DEVIATION REQUEST AND DECISION FORM

Project Name :	Retreat at PrairieRidge Filings 1-3 Preliminary Plan
Schedule No.(s) :	52280-00-024 & 52280-00-025
Legal Description :	See attached

A deviation from the standards of the ECM in **Chapter 2.2.5.E** is requested.

RETREAT AT PRAIRIERIDGE FILINGS 1-3			
PRELIMINARY PLAN			
FILING 1 & 2			
DESIGNED BY	MAW	SCALE	DATE
DRAWN BY	MAW	(H) 1" = 60'	SHEET 6 OF 28
CHECKED BY	(V) 1" = N/A	JOB NO.	1305.10

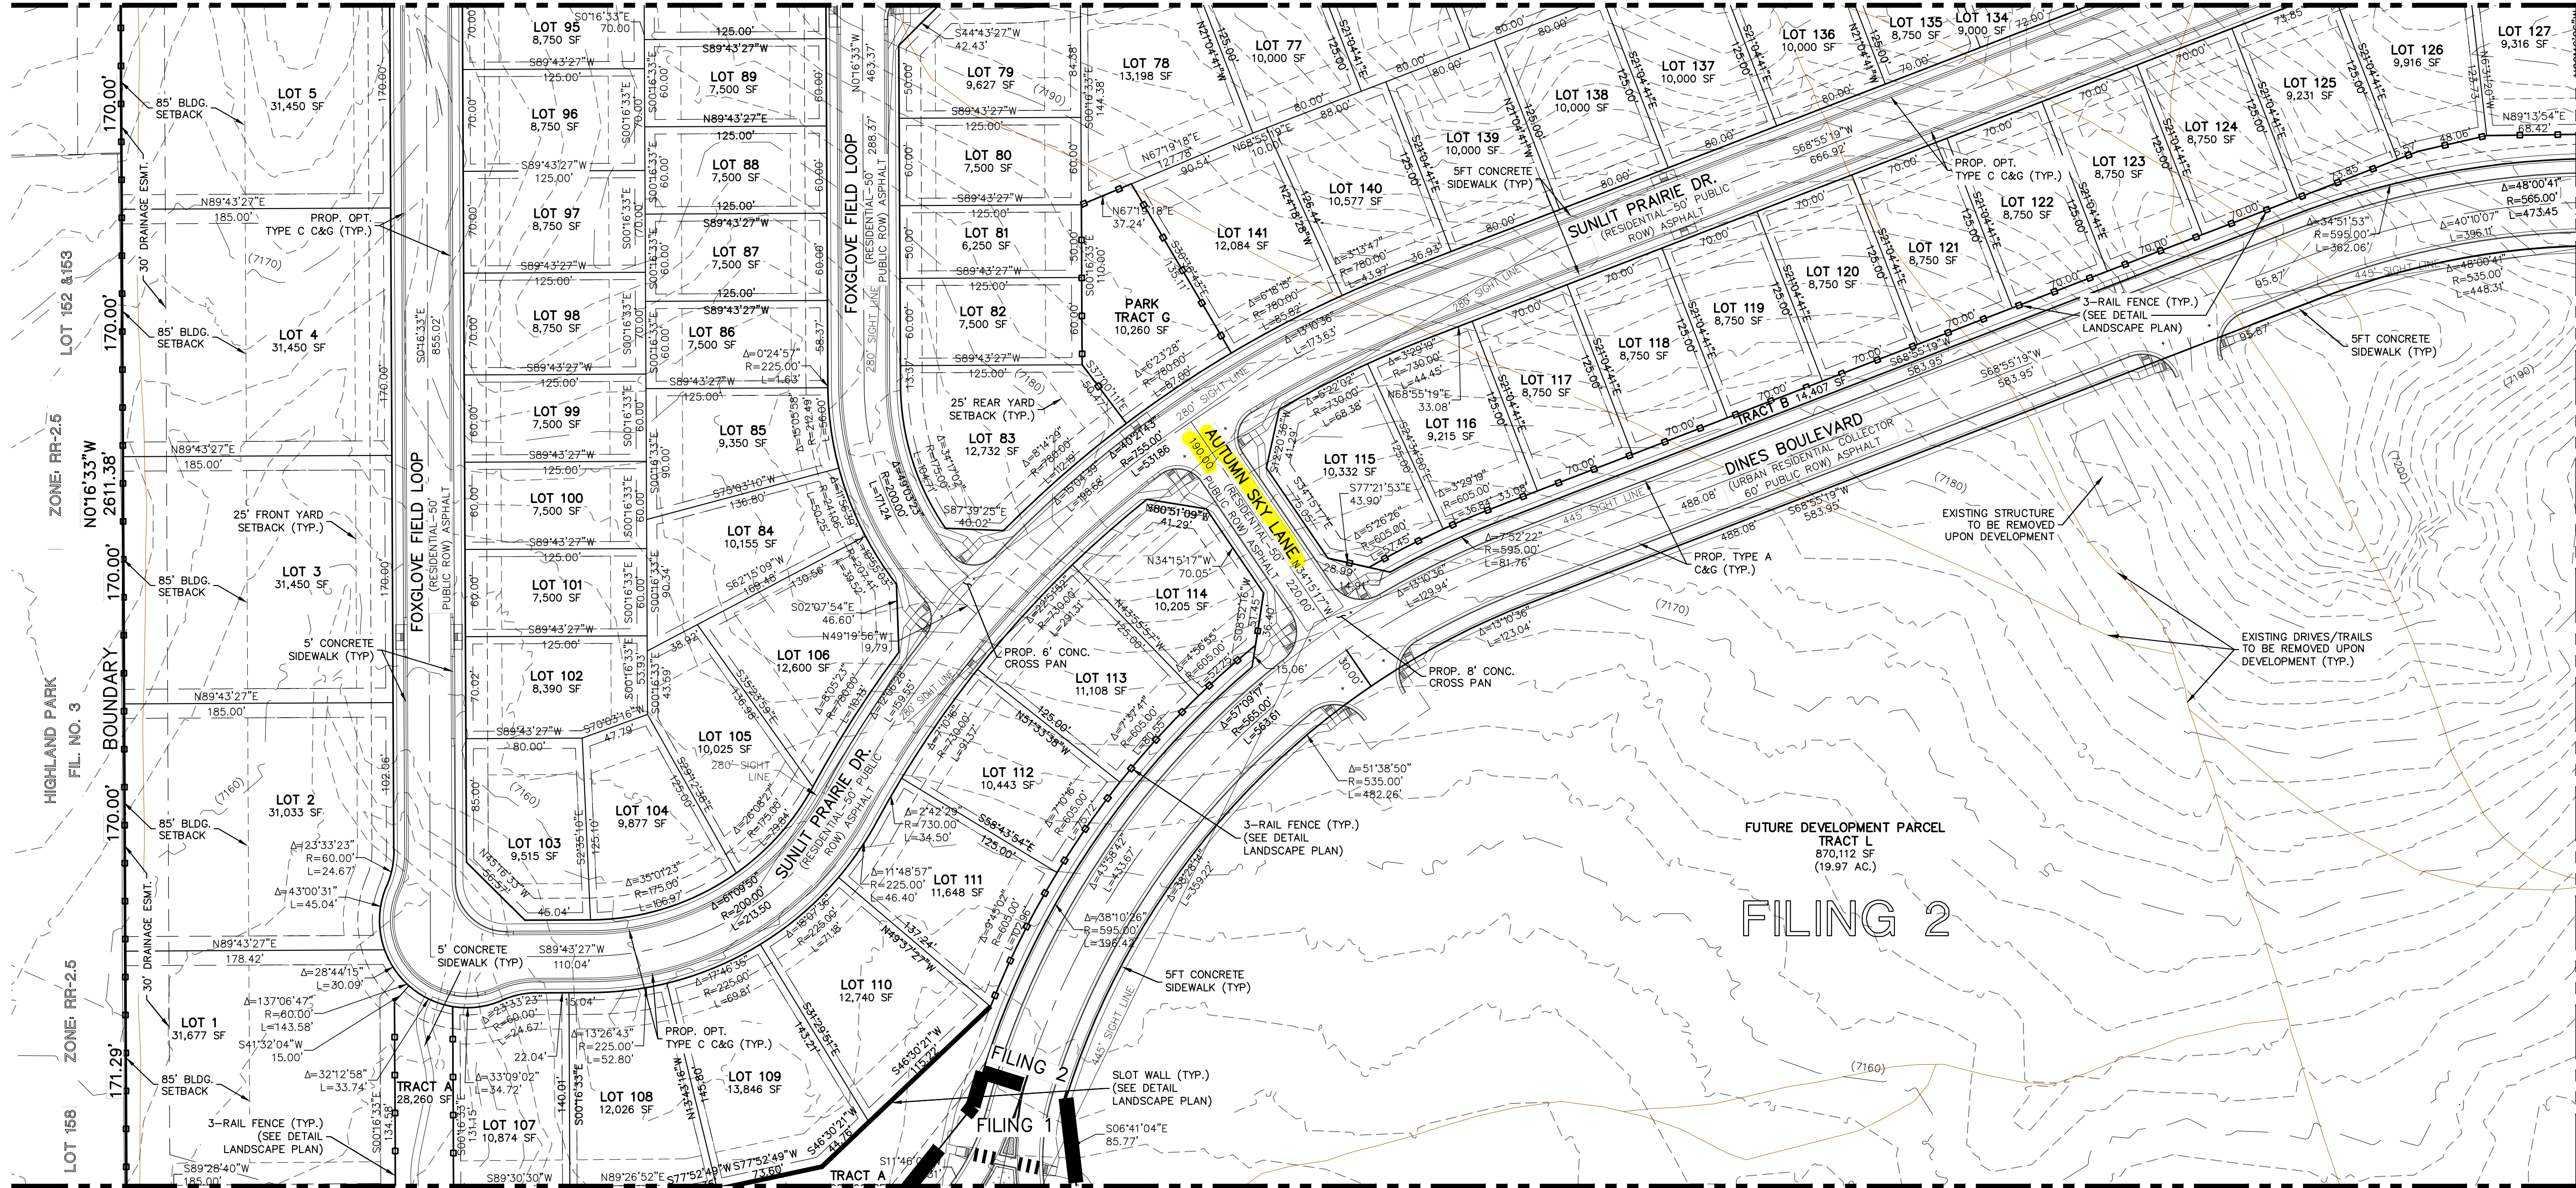
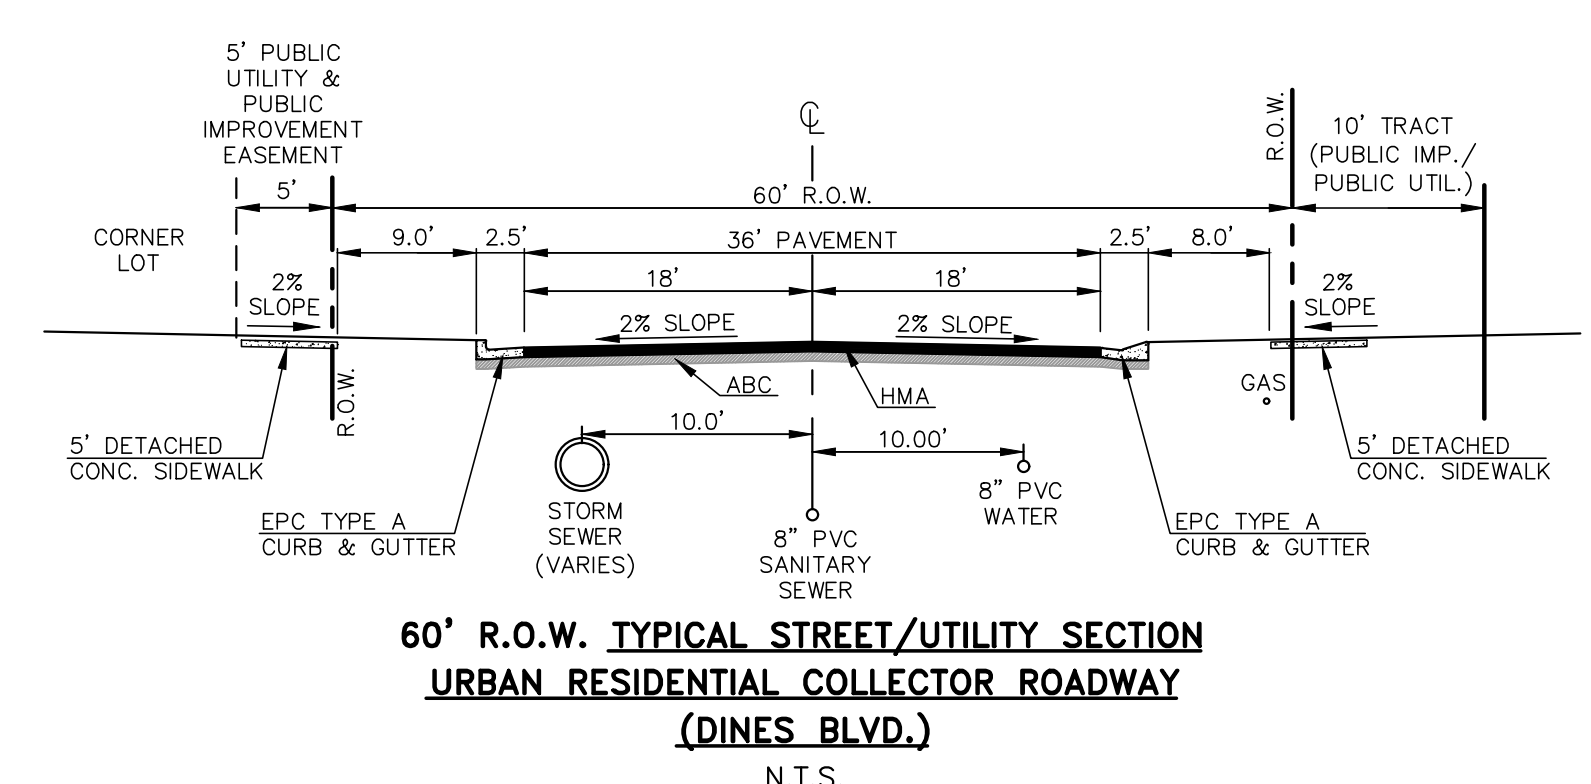
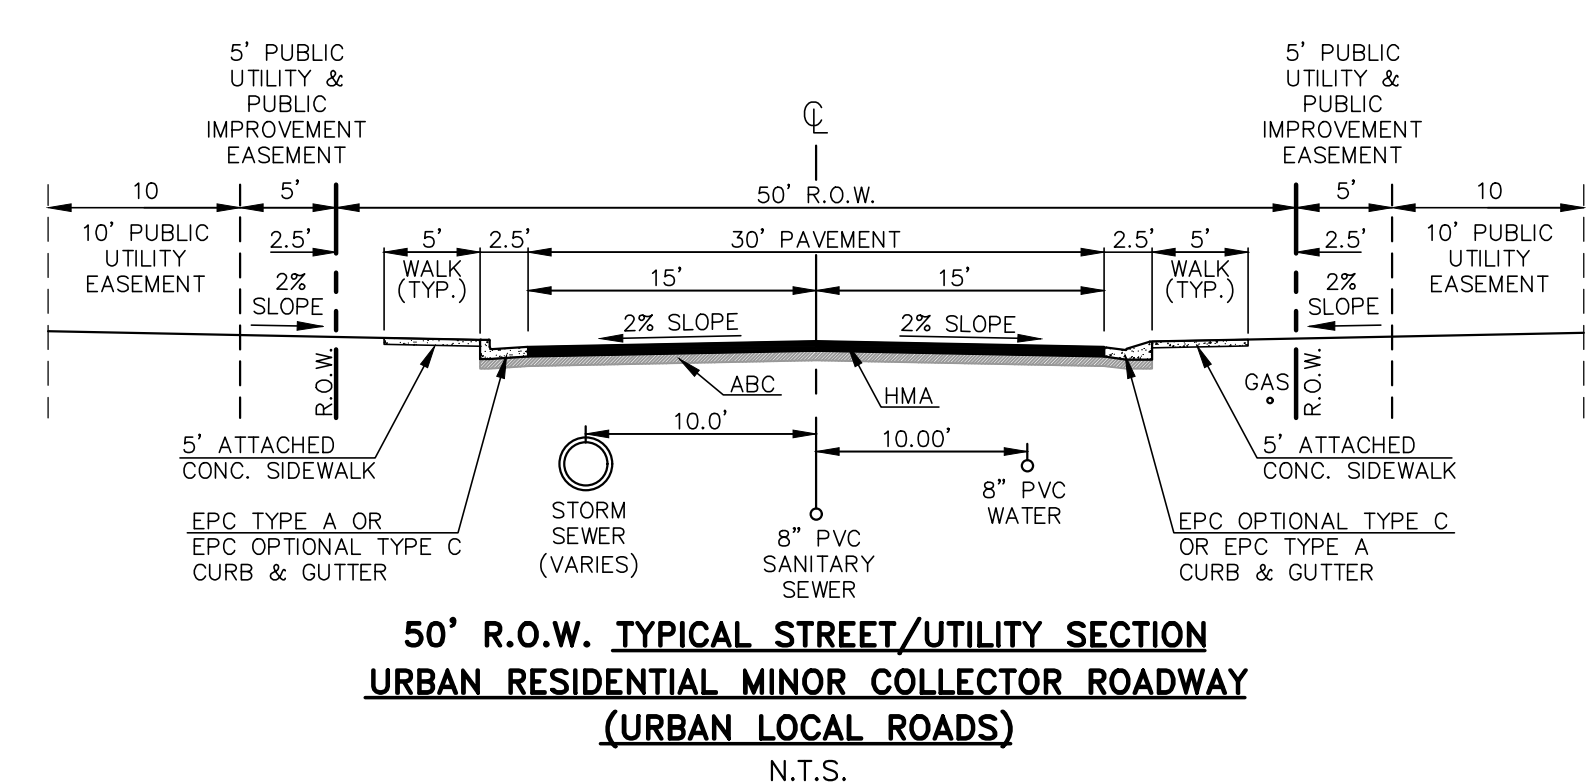
An urban local intersection is planned 190' away from collector road (CL to CL) rather than the required 200'. This design is based on a standard single family lot depth of 125' along with a 10' tract adjacent to the collector road. (Reference the Preliminary Plan – Autumn Sky Lane connection between Dines Blvd. and Sunlit Prairie Dr.)

The proposed alternative is to maintain a reasonable lot depth of 125' along with a 10' open space tract adjacent to the collector roadway as required for double frontage lots. This CL-CL distance between intersections then equals 190' rather than the 200' criteria.

In urban single family developments it is standard practice to have typical lot depths or 100'-120'. In this portion of the project, the lots are double frontage lots and an additional open space tract (10' in this case) is planned adjacent to the collector roadway. Thus, the 125' lot depth and 10' tract determined the 190' CL-CL spacing. (Reference the Preliminary Plan – Autumn Sky Lane connection between Dines Blvd. and Sunlit Prairie Dr.)

The Autumn Sky Lane access off of Dines Blvd. is only 10' shorter than criteria requires. This still leaves the ability to stack 4-5 cars at the stop sign at Autumn Sky Lane and Sunlit Prairie Dr. without affecting traffic on Dines Blvd.

This request has been determined to have met the criteria for approval. A deviation from Chapter 2.2.5.E of the ECM is hereby granted based on the justification provided.

RETREAT AT PRAIRIERIDGE FILINGS 1-3			
	PRELIMINARY PLAN			
FILING 1				
DESIGNED BY	MAW	SCALE	DATE	5/29/2024
DRAWN BY	MAW	(H) 1" = 60'	SHEET	8 OF 28
CHECKED BY		(V) 1" = N/A	JOB NO.	1305.10

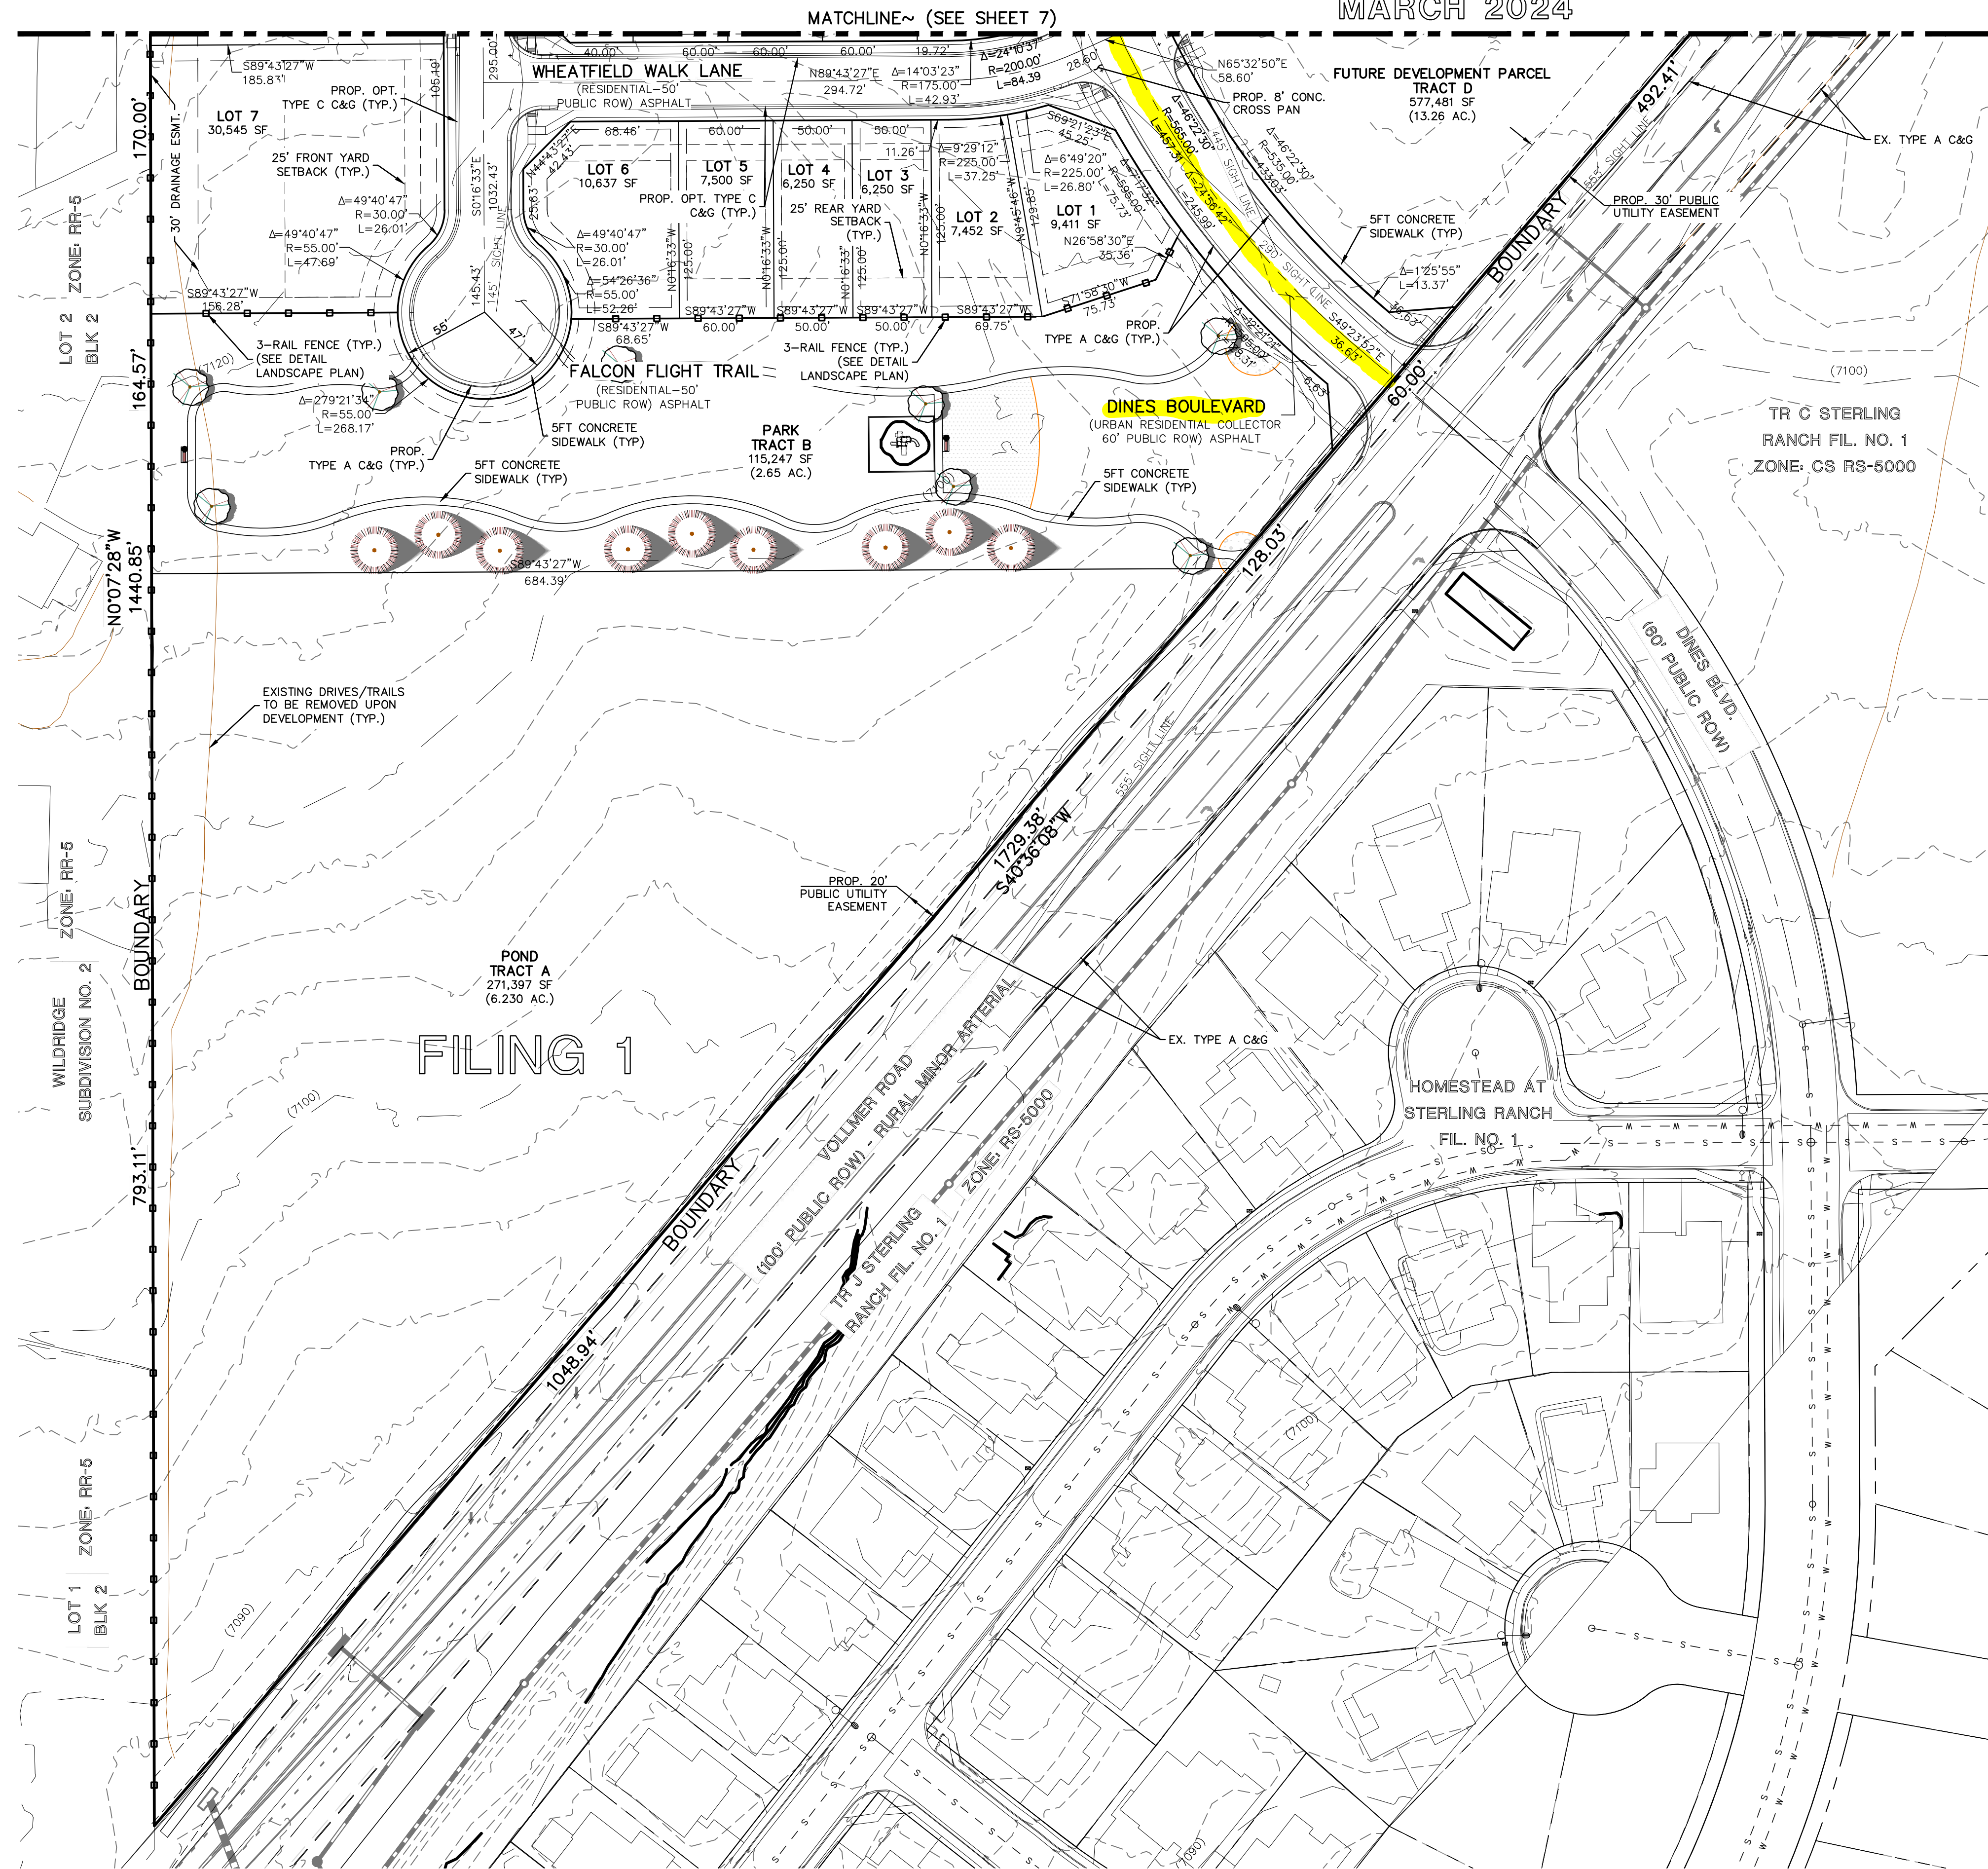
An urban local intersection is planned 282' away from a rural arterial (ROW to CL) rather than the required 330'. This design again is based on a standard single family lot depth of 125' along with a park tract adjacent to the arterial road. (Reference the Preliminary Plan – Dines Blvd. connection between Wheatfield Walk Lane and Vollmer Road)

The proposed alternative is again to maintain a reasonable lot depth of 125' along with a park tract between the lots and Vollmer Road as required by the 50' buffer and park as shown on the approved Jaynes Property Sketch Plan (SKP225) This ROW-CL distance between intersections then equals approximately 282' rather than the 330' criteria. Incidentally, the CL-CL distance equals 332'.

The southern portion of the project has a similar condition, however, there is a park planned between the lots and Vollmer Road. The 125' lot depths and the varying width of the park in this area determine the 282' ROW-CL spacing. (Reference the Preliminary Plan – Dines Blvd. connection between Wheatfield Walk Lane and Vollmer Road)

The Wheatfield Walk Lane access off of Dines Blvd. is 48' shorter than criteria requires. However, this still leaves the ability to stack 7-8 cars at the int. of Wheatfield Walk Lane and Dines Blvd. waiting to turn left without affecting traffic on Vollmer Rd. There is no stop condition on Dines Blvd. at this int.
